TOWNHOUSES BUILDING D

CLARENDON HILL PHASE TWO POAH

ZONING SUBMISSION 06/15/2026 REV 07/22/2026

ZONING DIMENSIONAL STANDARDS TABLE

Z-003

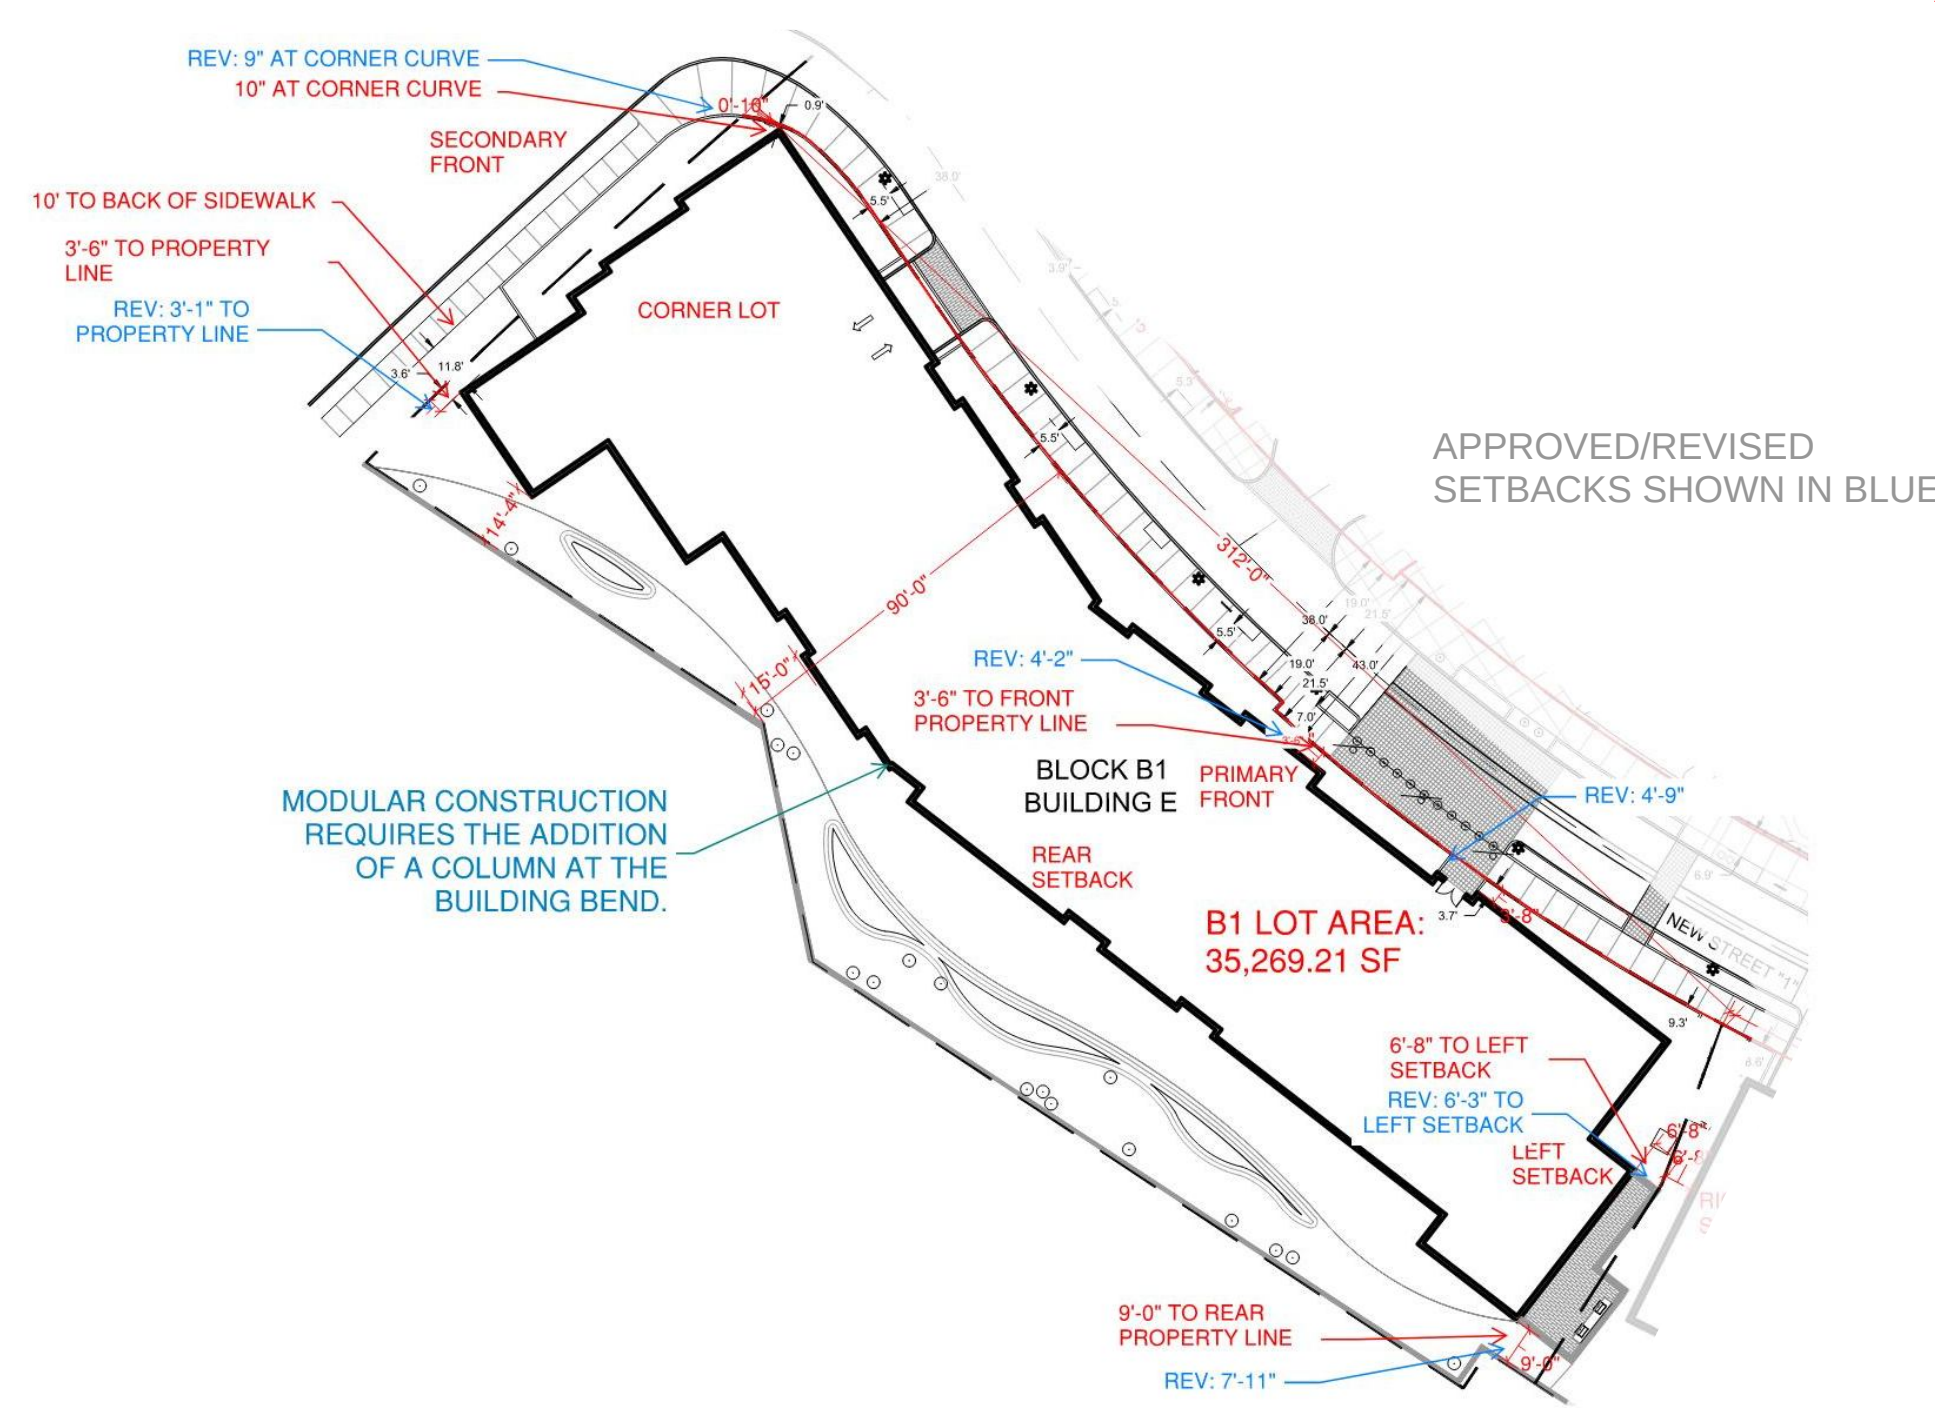
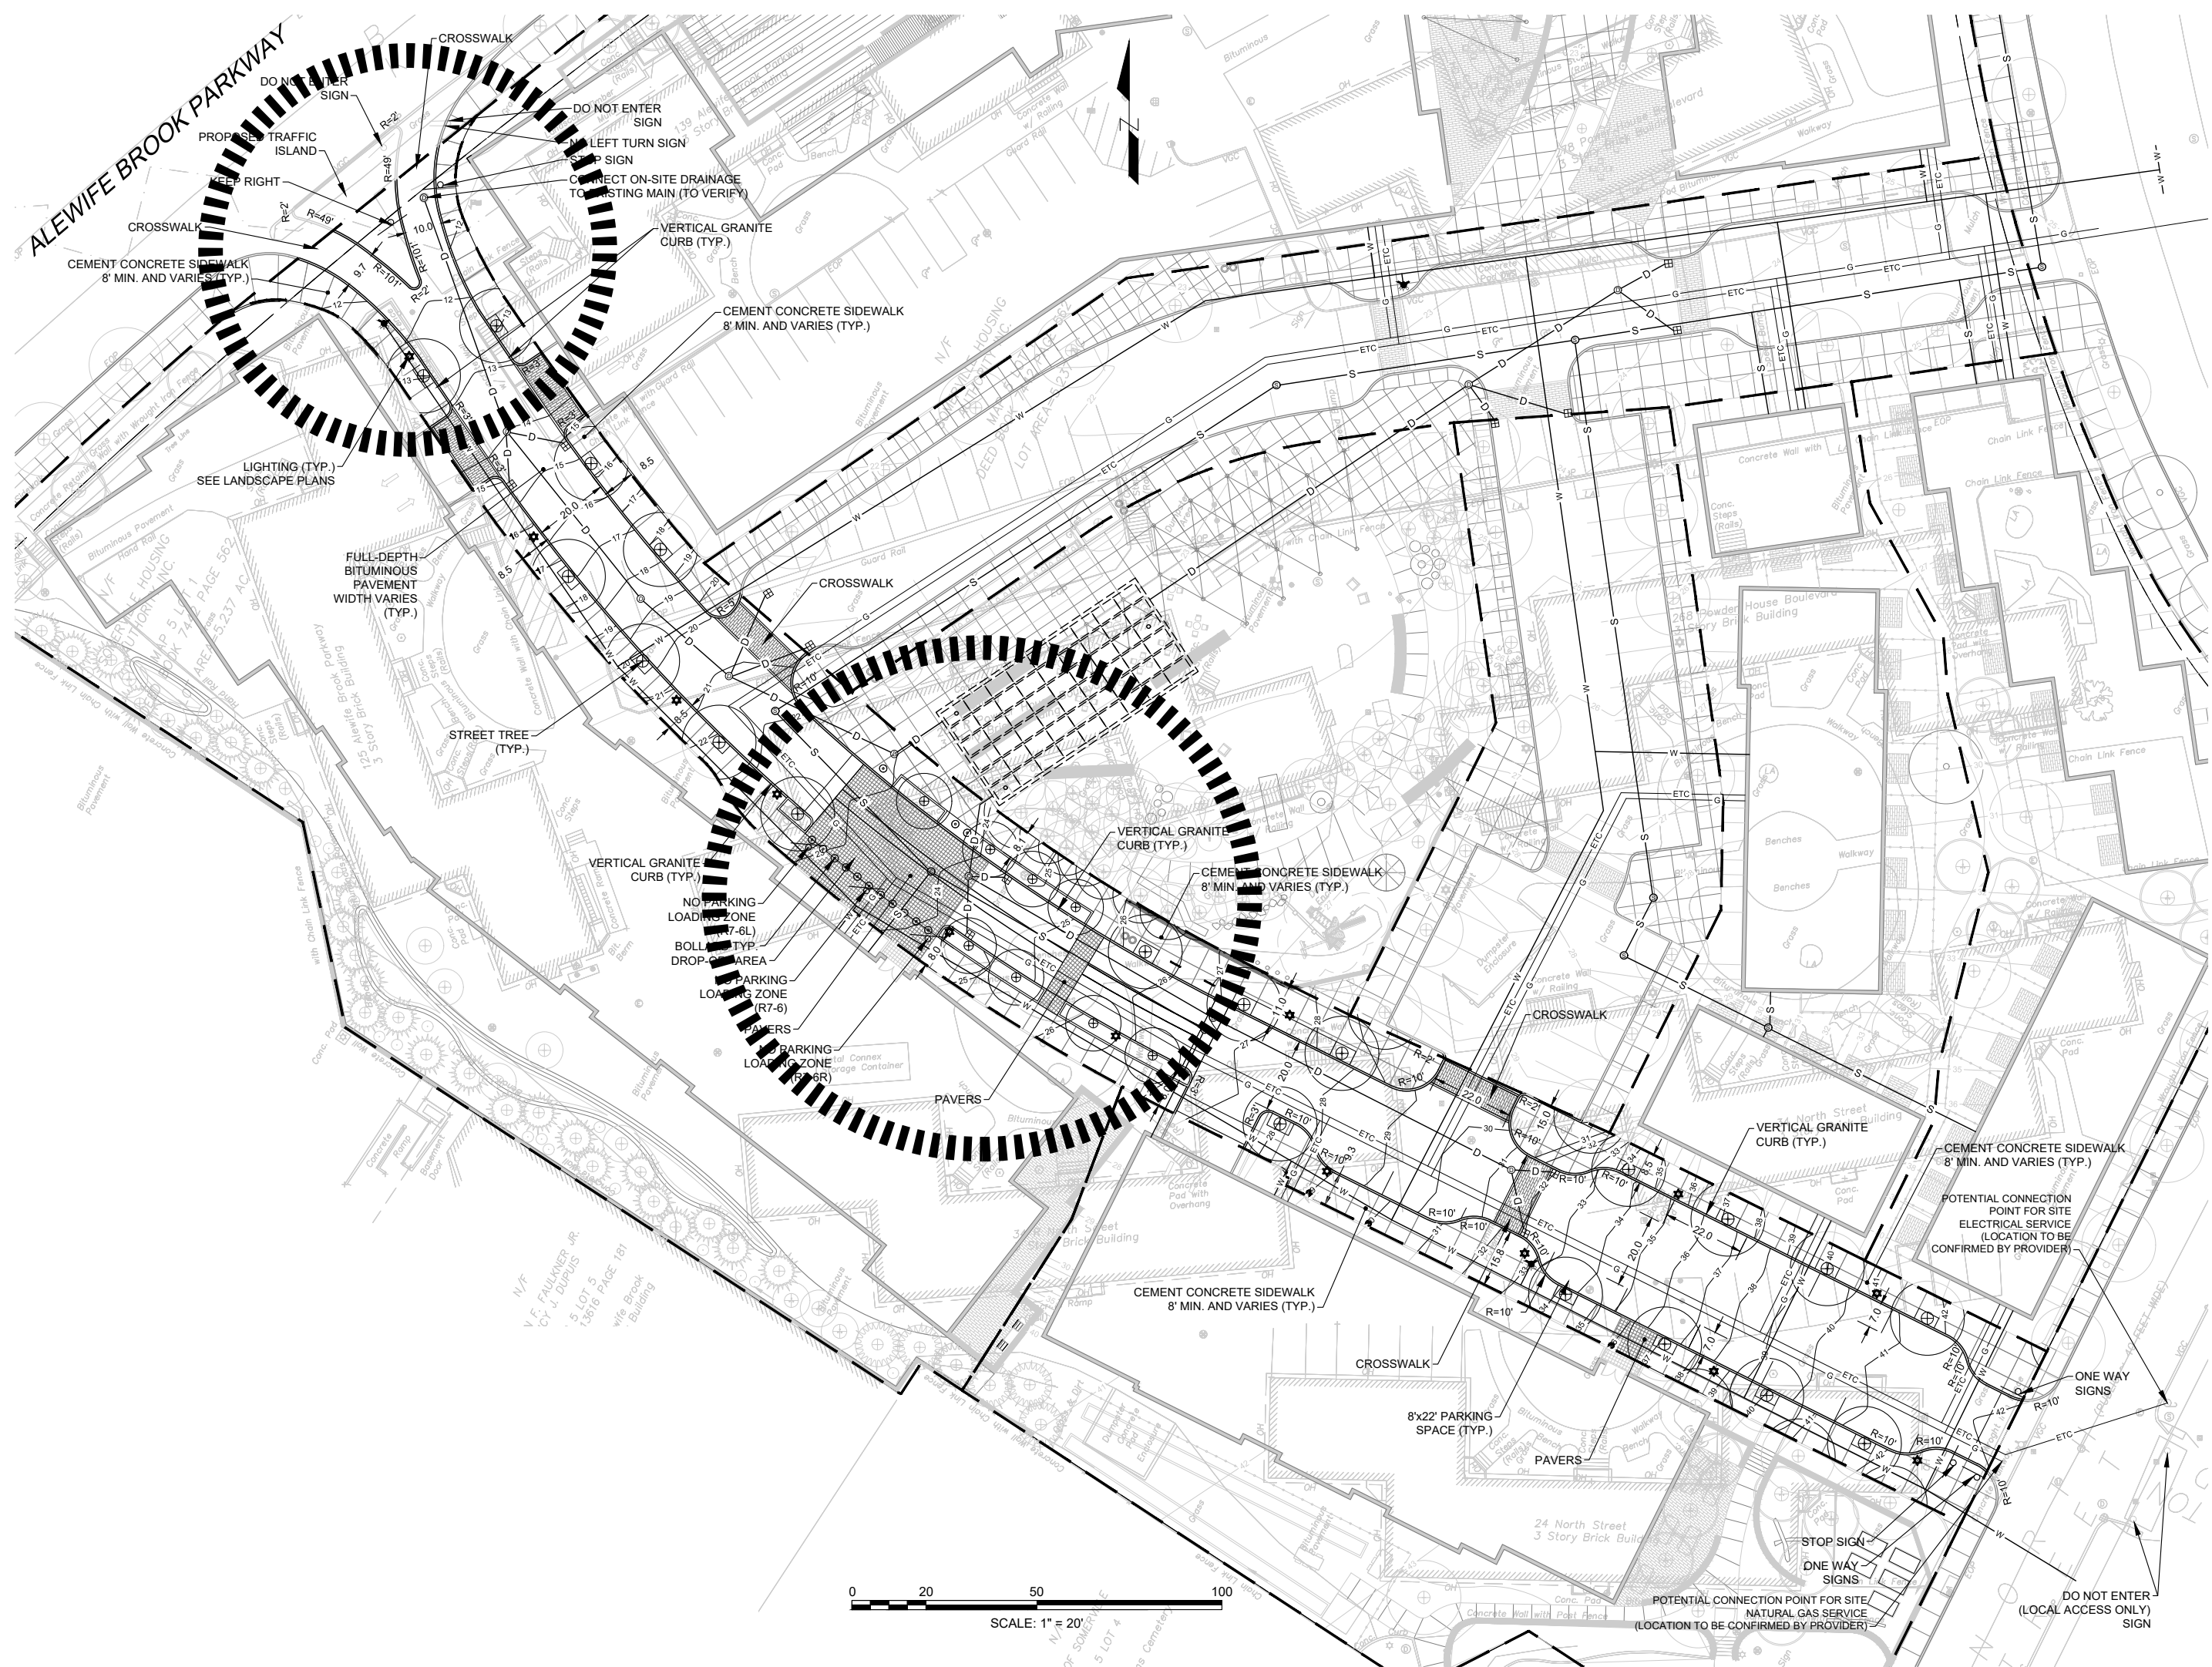
PROPOSED: DIMENSIONAL REVISIONS TO ZONING SETBACKS

PROPOSED JUNE 15, 2026:
PHASE 2 ZONING SETBACKS

Z-004

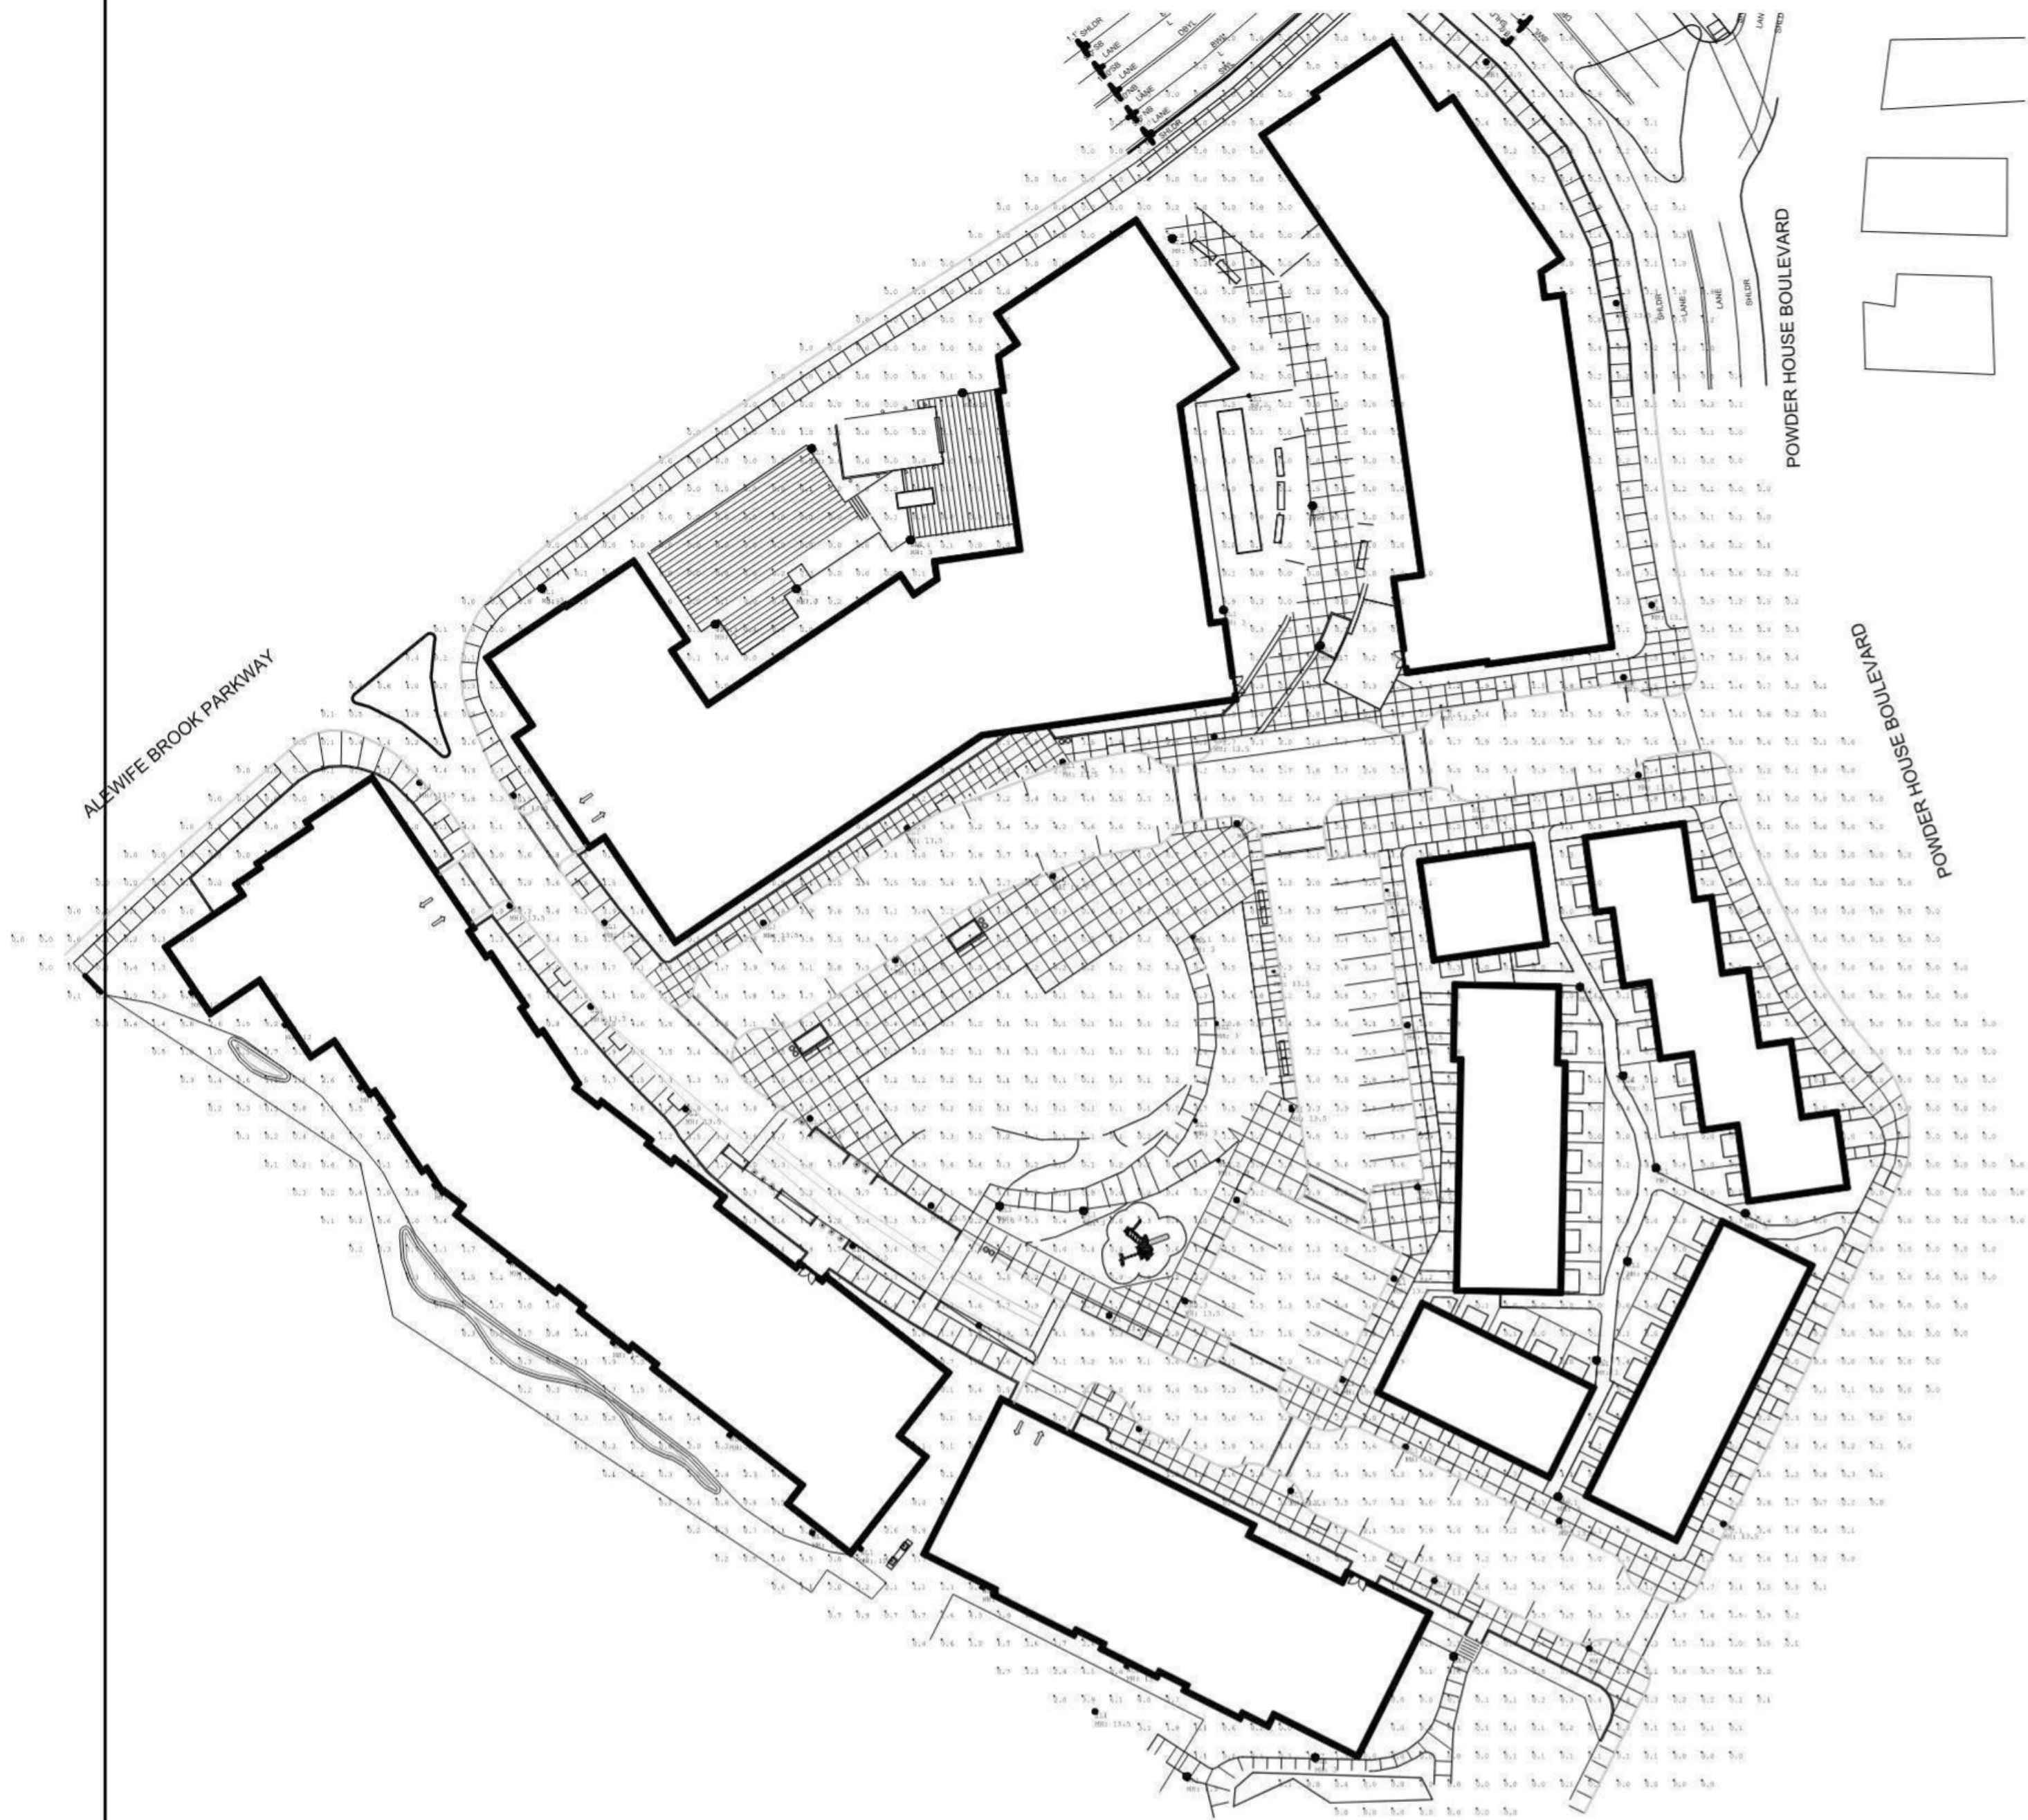
PHASE 1 STREET TREES (4 TOTAL)
PHASE 2 STREET TREES (42 TOTAL)
PHASE 3 STREET TREES (11 TOTAL)

TOTAL PROPOSED STREET TREES (57 TOTAL)
(NOT INCLUDING STREET TREES
ALONG NORTH STREET AND
POWDERHOUSE BLVD)

PROPOSED JUNE 15, 2026: PHASE 2 TREE PLANTING PLAN
